Subject: Arkansas Nuclear One - Unit 2
Docket No. 50-368
License No. NPF-6
ANO-2 Cycle 16 Core Operating Limits Report

CORE OPERATING LIMITS REPORT

FOR CYCLE 16

This CORE OPERATING LIMITS REPORT (COLR) has been prepared in accordance with the requirements of Arkansas Nuclear One - Unit 2 (ANO-2) Technical Specification 6.9.5 for ANO-2's Cycle 16. This is Revision 0 of the Cycle 16 COLR.

FIGURE 1

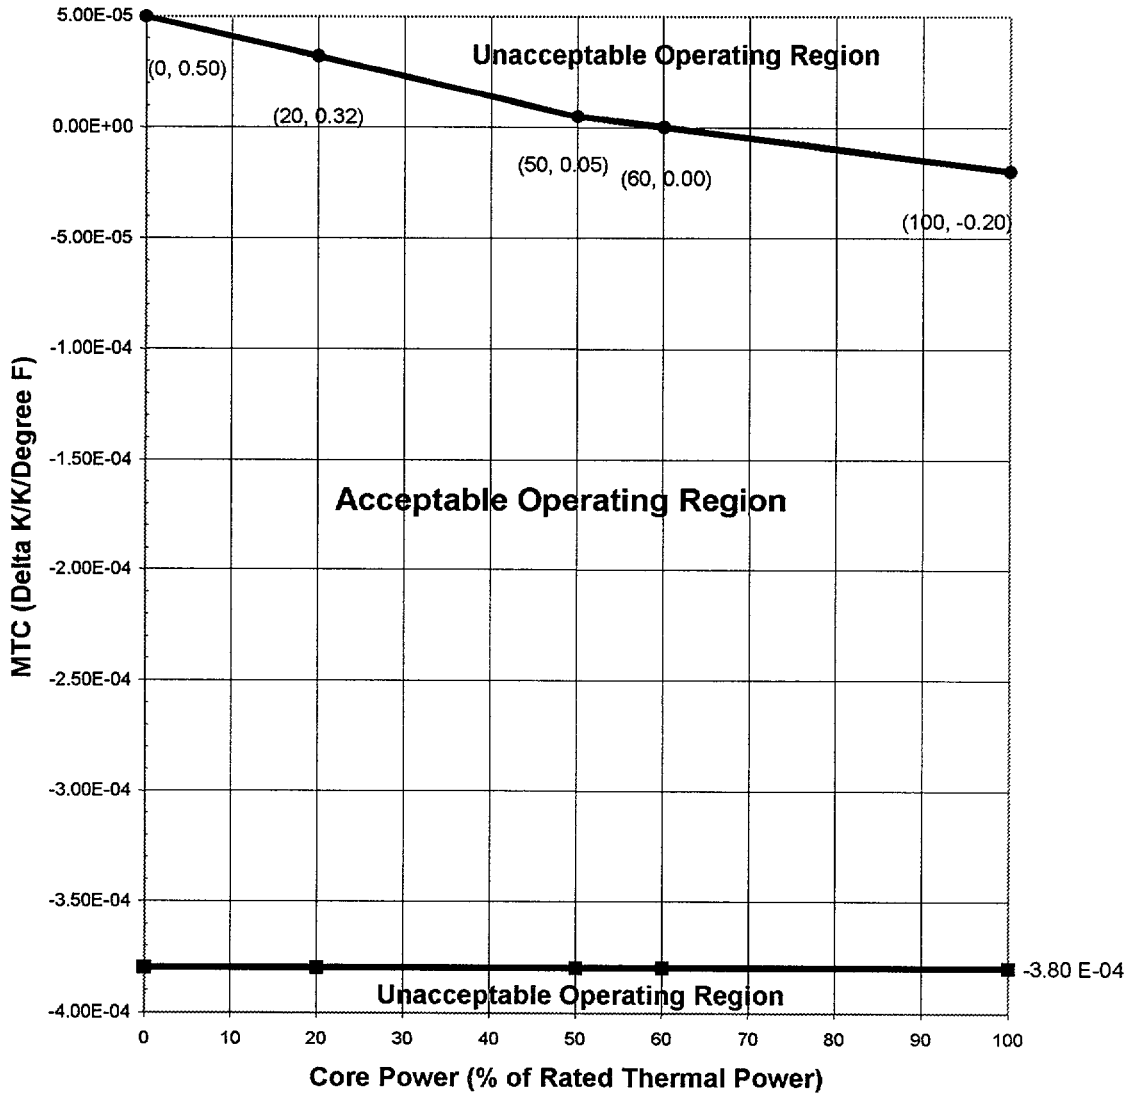
- The lower limit for MTC (Figure 1) has been revised from $-3.4 \text{ E-04 } \Delta\text{k/k/}^\circ\text{F}$ to $-3.8 \text{ E-04 } \Delta\text{k/k/}^\circ\text{F}$.

- Modified the EFPD breakpoints in the Core Operating Limit for Moderator Temperature Coefficient (MTC) that specifies where a less positive (burnup dependent) MTC was credited in the safety analyses. The first breakpoint is at 124.9 EFPD. The second breakpoint is 353.2 EFPD.

The Moderator Temperature Coefficient (MTC) shall be in accordance with Figure 1. The Beginning of Cycle (BOC) positive COLR MTC limit line of Figure 1 is from BOC to 124.9 EFPD. From 353.2 EFPD to End of Cycle (EOC) the positive COLR MTC limit line is linear from an MTC of $0.0 \text{ E-}4 \Delta k/k/^{\circ}\text{F}$ at 0% power to an MTC of $-1.0 \text{ E-}4 \Delta k/k/^{\circ}\text{F}$ at 100% power which is bounded by the BOC positive MTC limit. Between 124.9 EFPD and 353.2 EFPD the positive MTC limit may be interpolated linearly with burnup.

FIGURE 2

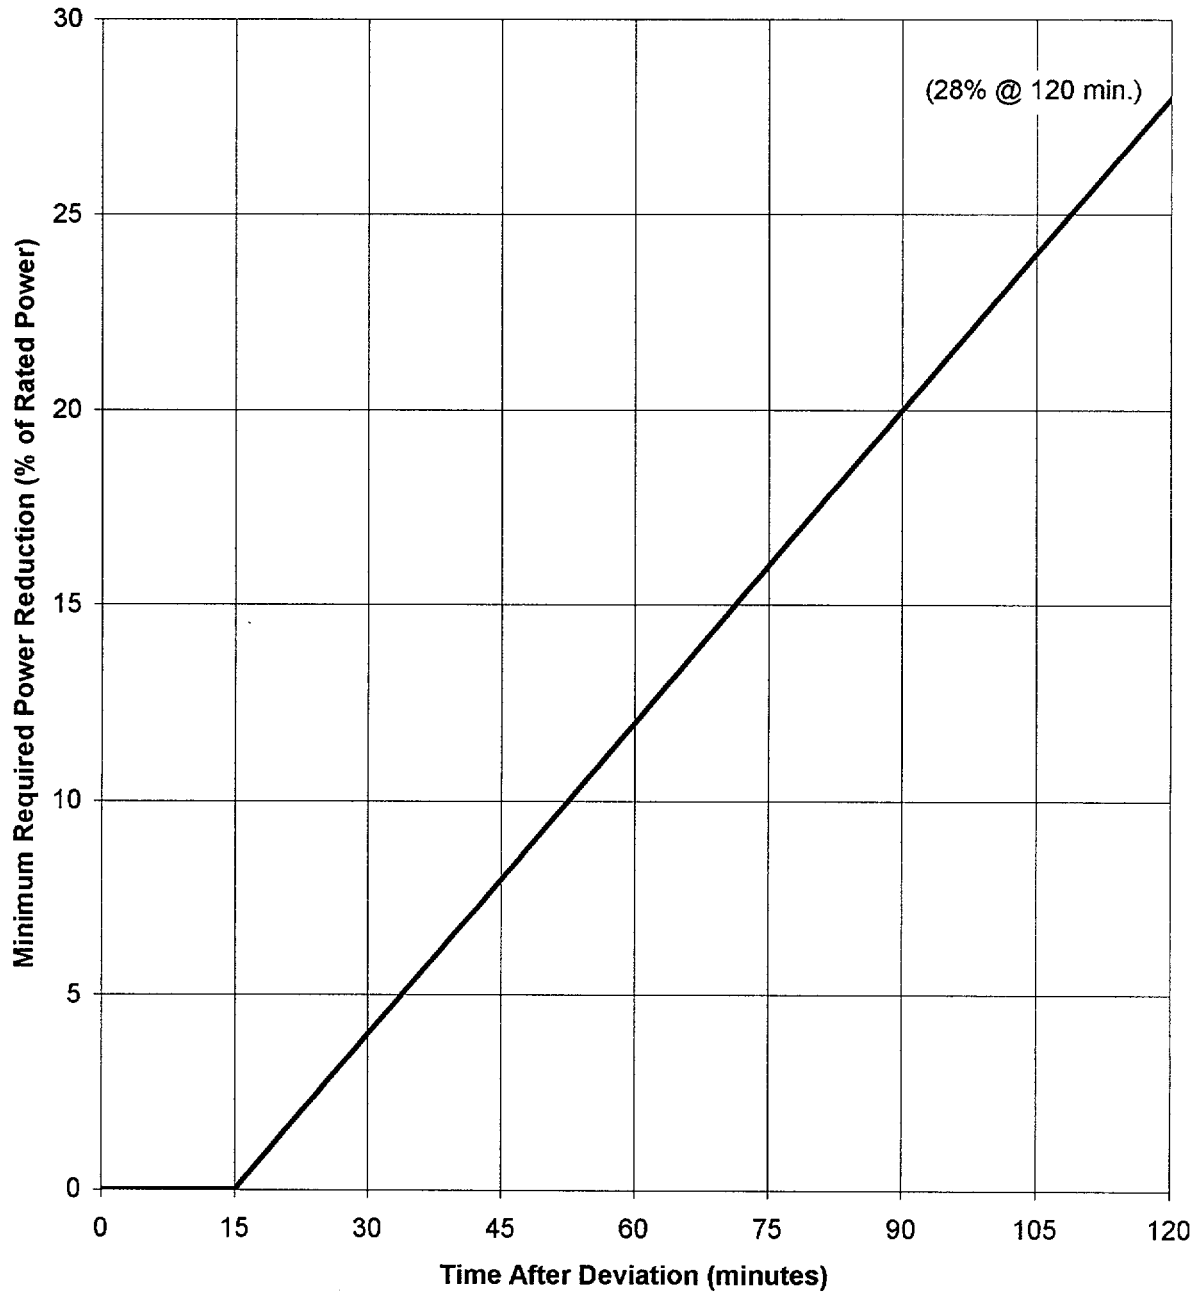
- The required downpower and time frame for a dropped CEA (Figure 2) has changed. Also the title to this figure was changed to "Required Power Reduction After Inward CEA Deviation".

***When core power is reduced to 60% of rated power per this limit curve, further reduction is not required**

FIGURE 4

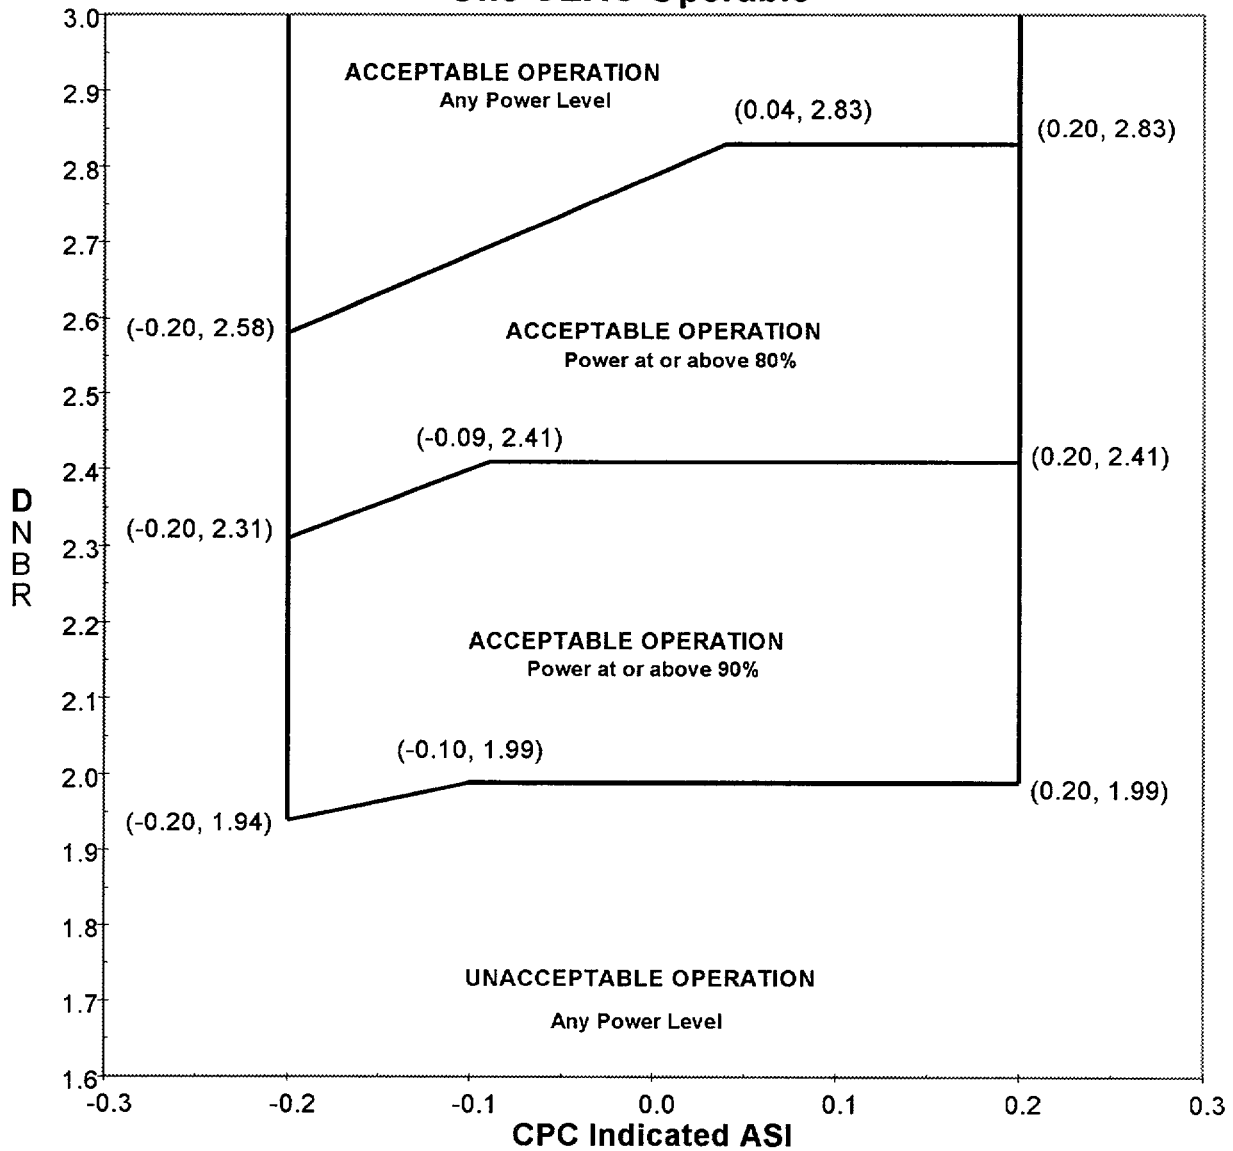
- DNBR Margin with COLSS out of service and at least one CEAC operable (Figures 4). Added a note to this figure to clarify that DNBR greater than that indicated at the top of the figure is acceptable, provided the indicated ASI limits remain between the bounds that are shown for lower DNBR.

NOTE: DNBR greater than that indicated at the top of the figure is acceptable, provided the indicated ASI limits remain between the bounds that are shown for lower DNBR.

FIGURE 5

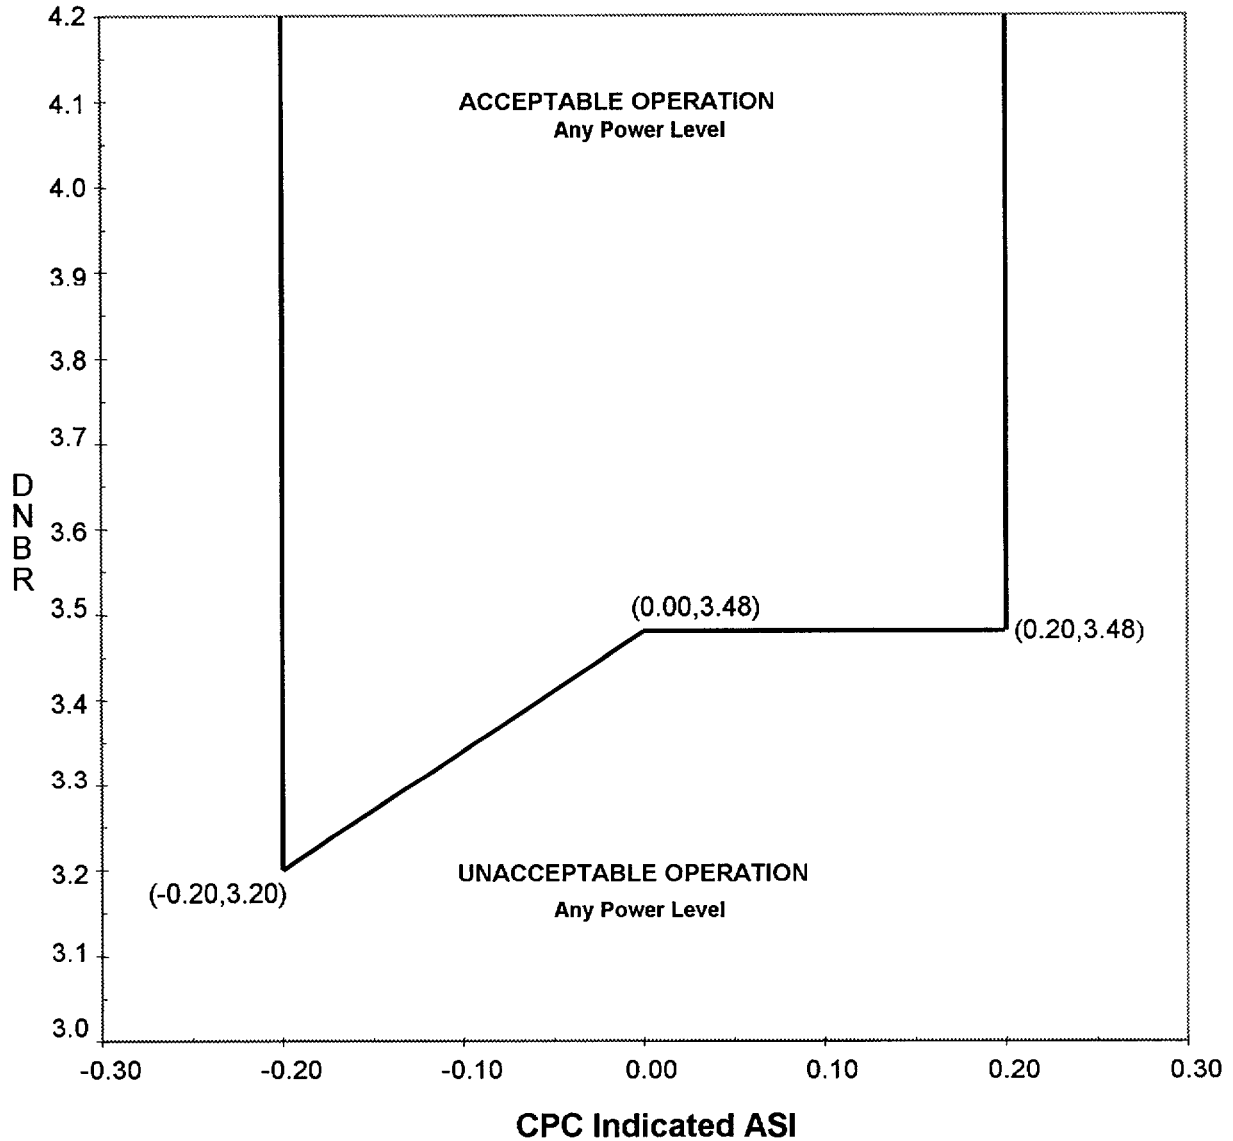
- DNBR Margin with COLSS out of service and both CEACs inoperable (Figure 5). Added a note to this figure to clarify that DNBR greater than that indicated at the top of the figure is

acceptable, provided the indicated ASI limits remain between the bounds that are shown for lower DNBR.

- **NOTE:** DNBR greater than that indicated at the top of the figure is acceptable, provided the indicated ASI limits remain between the bounds that are shown for lower DNBR.
